SAFETY RECALL NOTICE

Re: Rearview mirrors lenses may dislodge - Decreased visibility - Revised Bulletin

February 9, 2023 Subject: **Rearview Mirror Lenses May Dislodge - Decreased Visibility** No. **2022-19**

REVISION ▶ 1
March 16, 2023 ◀

MIRROR HOUSING ASSEMBLY REPLACEMENT

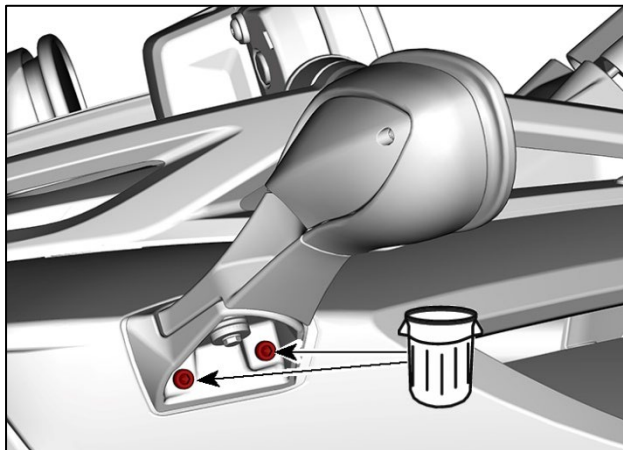
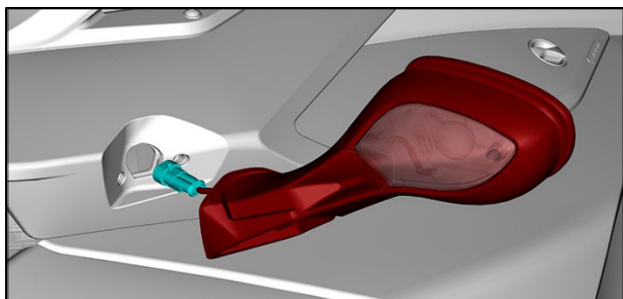
1. Remove and discard the two housing retaining screws.

2. Gently pull the mirror housing and disconnect the mirror light harness connector.

3. Discard the mirror housing assemblies.
4. Clean threads on vehicle.
5. The installation is the reverse of the removal procedure.

TIGHTENING TORQUE	
Mirror Housing Retaining Screw	3.5 N•m ± 0.5 N•m (31 lbf•in ± 4 lbf•in)
